Addendum

New Glasgow Public Library & PARL Headquarters Revitalization

| 16 April 2024 | 23-053         | 04         |

**MSK08**

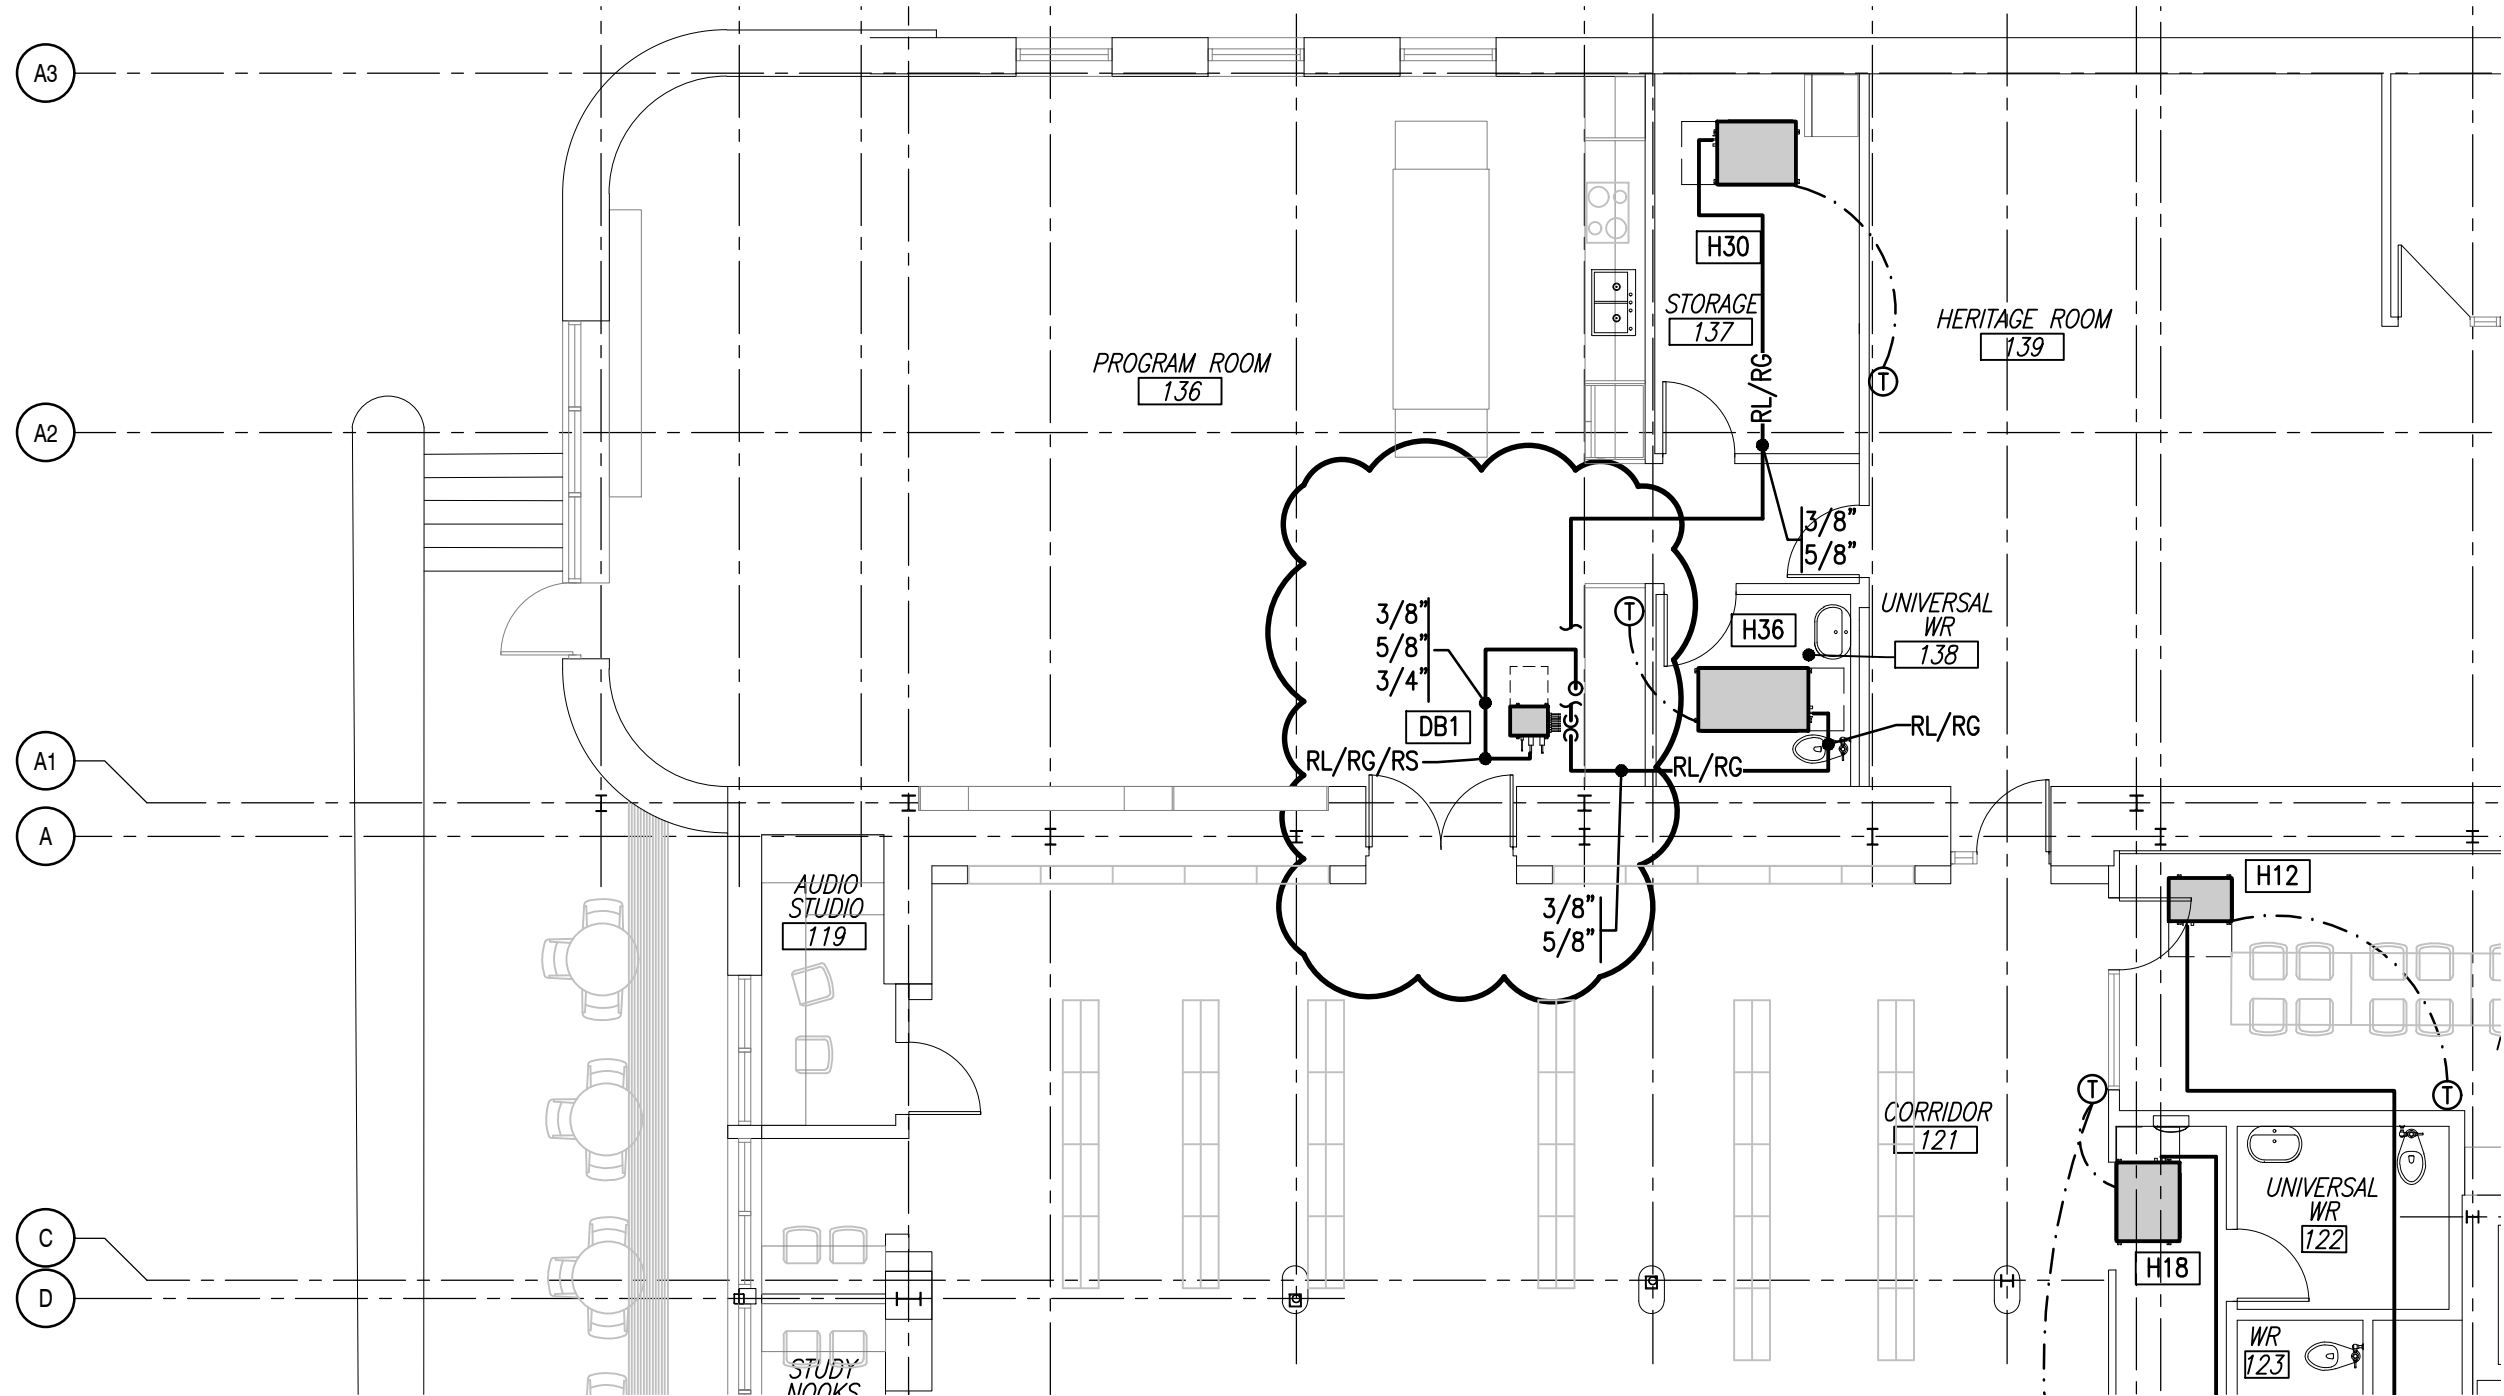
**2.13 Reference Drawing MH-501 Heating – Details and Schematic:** Revise with MSK08
